BID ADDENDUM NO. 1

Project Name: Raccoon Town
Owner: Port Gamble S'Klallam Tribe
Engineer of Record: Pat Fuhrer, P.E. – MAP Ltd

Addendum Date: April 2, 2026
Bid Due Date Unchanged: 12:00 pm April 15, 2026

C-10.01

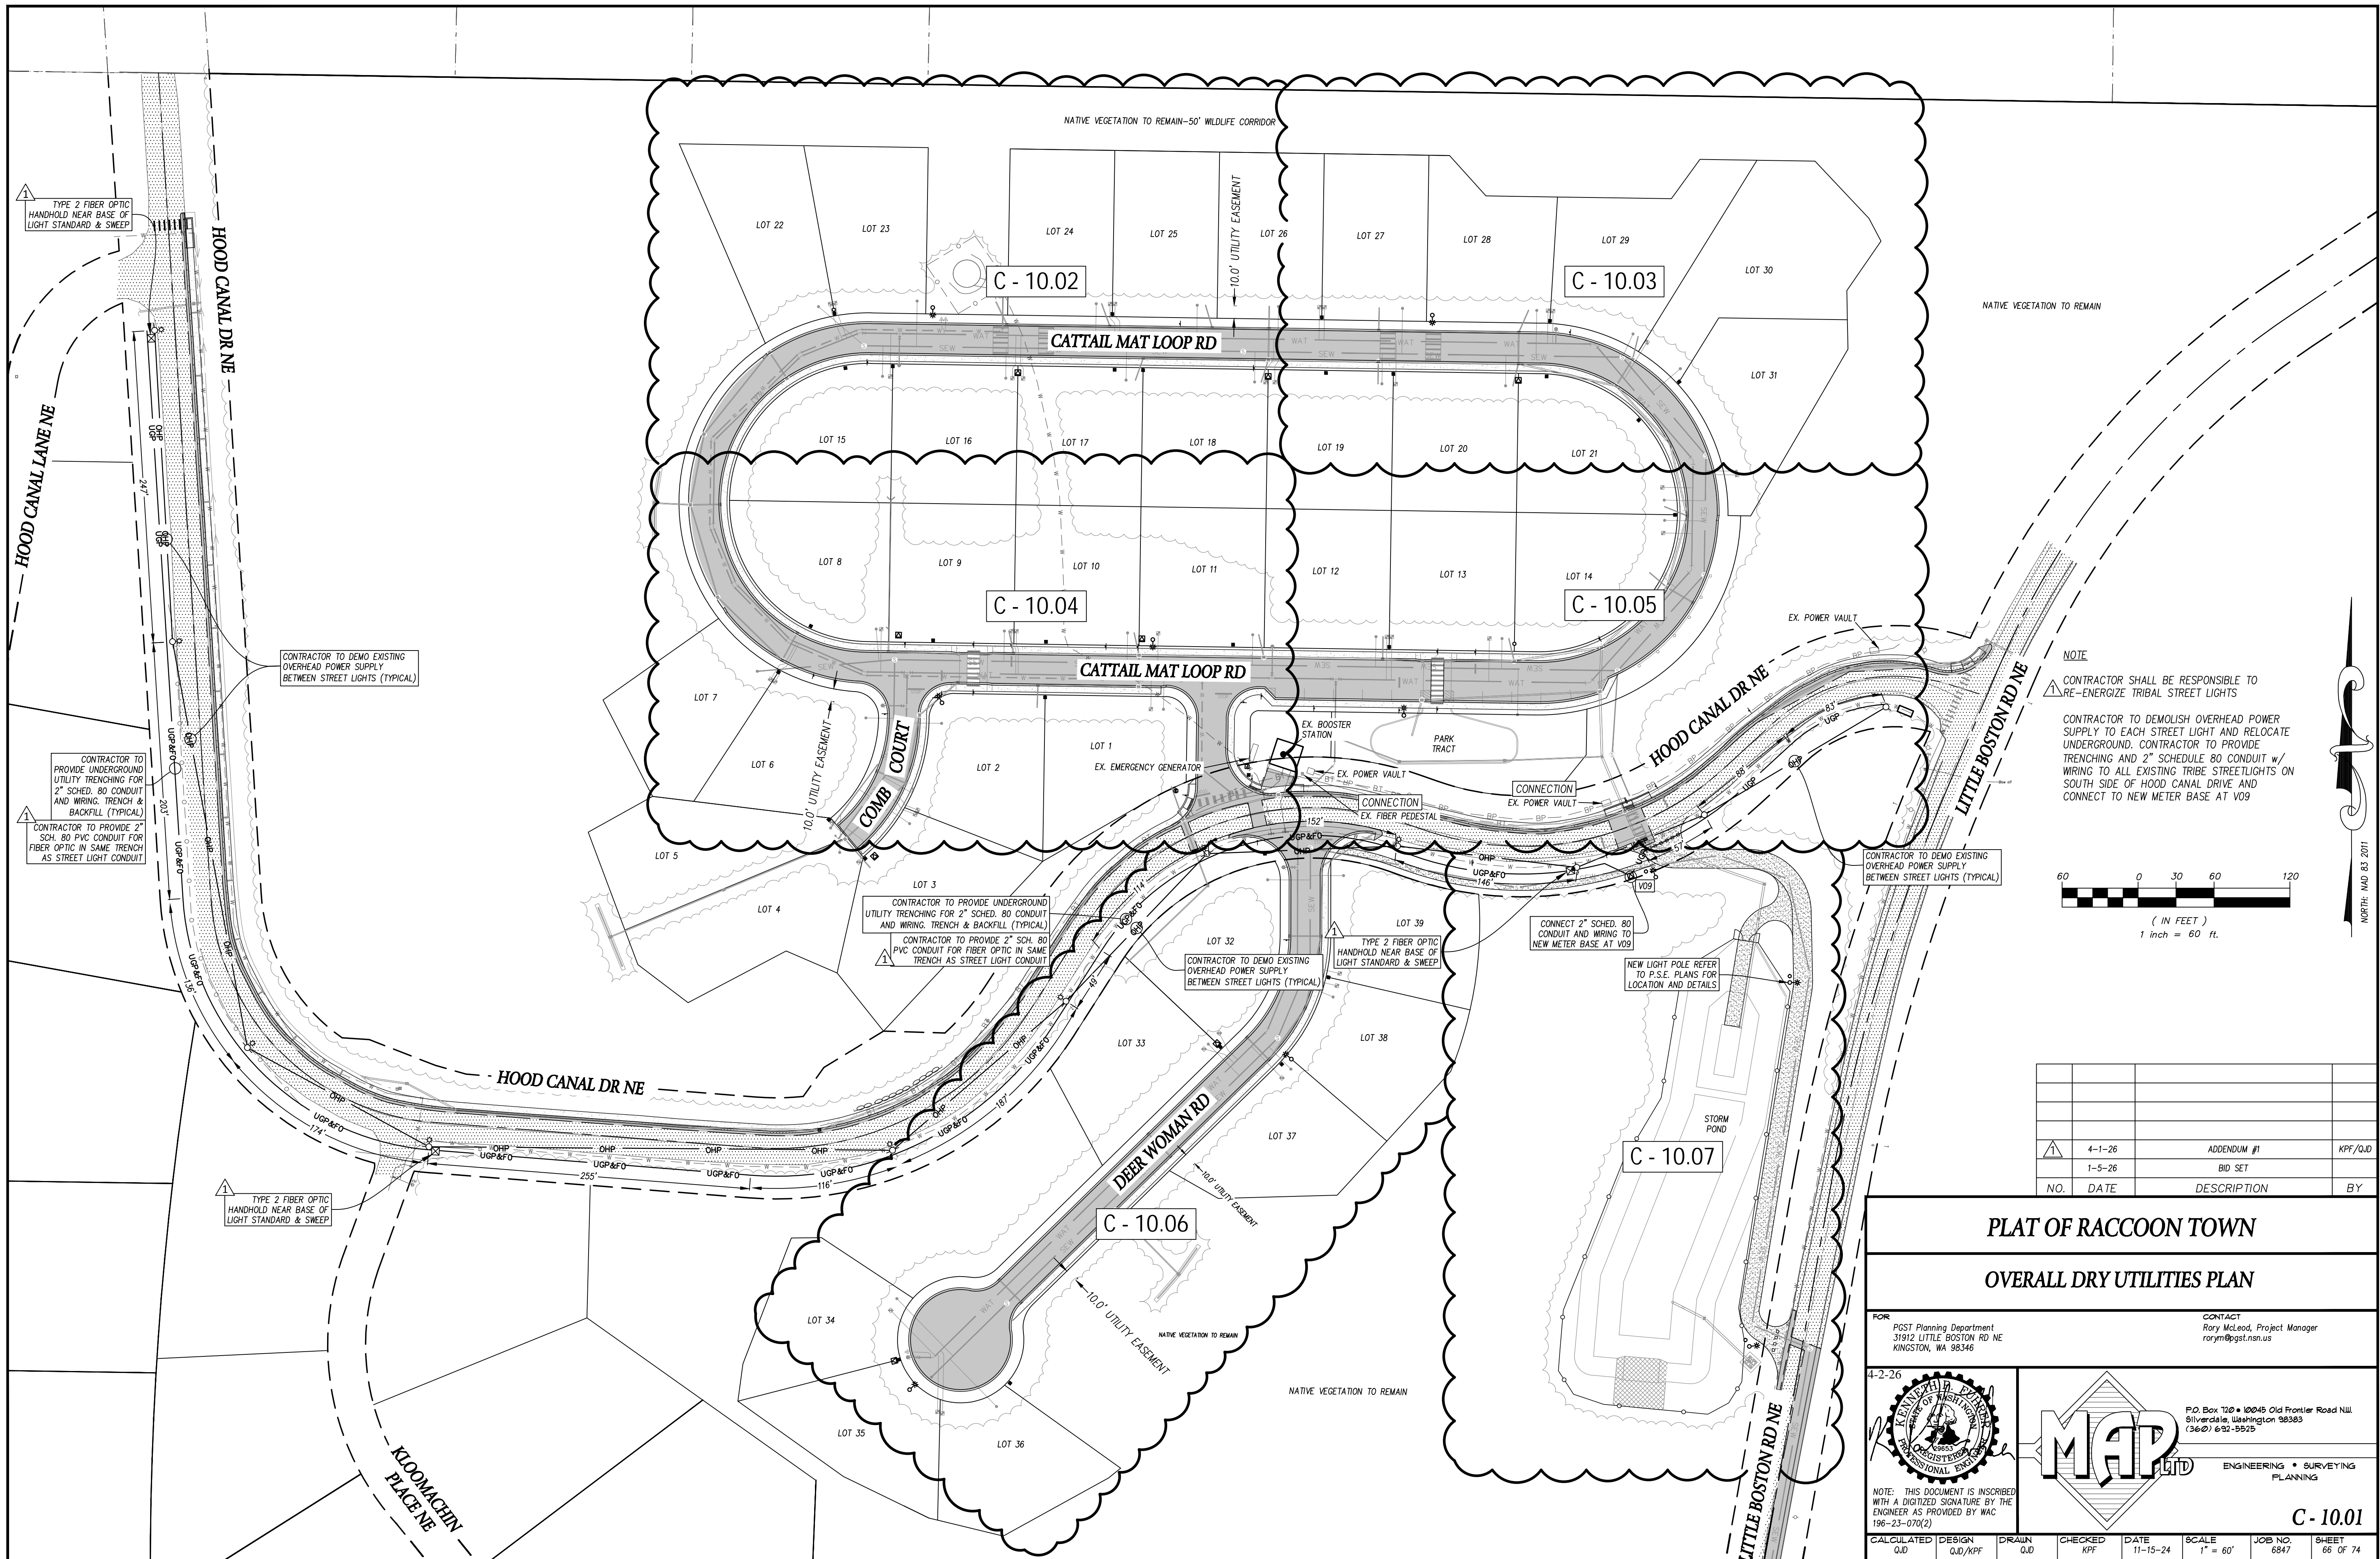
Please insert the attached revised plan sheets C-10.01, C-10.04, C-10.05, C-10.06, and C-10.07 dated 4-1-26 and sealed 4-2-26 into the bid set plans. These sheets were updated to include the Owner's request at the pre-construction meeting to **ADD** a second conduit and handholds to the street light trench for the Owner to install a fiber line. Also, a note was **ADDED** to clarify that the intent that the Contractor is responsible for re-energizing the Owner's street lights in Hood Canal Drive after undergrounding the conduit and pulling the new street light wire.

NOTE
 CONTRACTOR SHALL BE RESPONSIBLE TO RE-ENERGIZE TRIBAL STREET LIGHTS
 CONTRACTOR TO DEMOLISH OVERHEAD POWER SUPPLY TO EACH STREET LIGHT AND RELOCATE UNDERGROUND. CONTRACTOR TO PROVIDE TRENCHING AND 2" SCHEDULE 80 CONDUIT w/ WIRING TO ALL EXISTING TRIBE STREETLIGHTS ON SOUTH SIDE OF HOOD CANAL DRIVE AND CONNECT TO NEW METER BASE AT V09
